INTERNATIONAL STANDARD ISO/IEC 14496-3:2001/Amd.2:2004
TECHNICAL CORRIGENDUM 1

Information technology — Coding of audio-visual objects —

Part 3: Audio

AMENDMENT 2: Parametric coding for high-quality audio

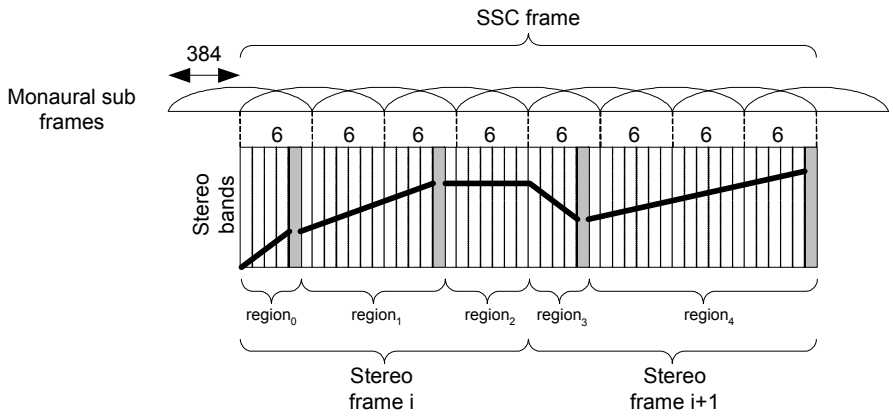
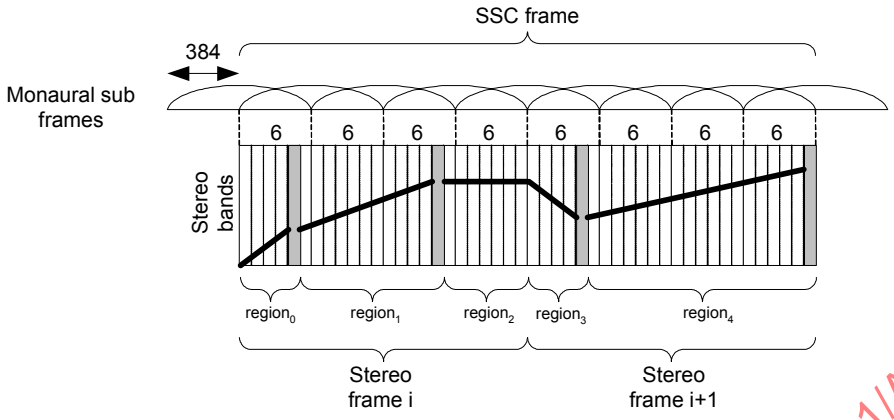
In ISO/IEC 14496-3:2001/Amd.2:2004, subclause 8.6.4.4, Figure 8.24, replace caption (modified parts are marked in gray):

Figure 8.24 - One SSC frame comprises two stereo frames of data. The solid line illustrates the interpolation between stereo parameters for slots that have not been assigned stereo parameters to

Figure 8.24 - One SSC frame comprises two stereo frames of data. The solid line illustrates the interpolation between stereo parameters for slots that have not been assigned stereo parameters to. Note that the delay introduced by the hybrid QMF analysis filterbank has been compensated for in this figure.
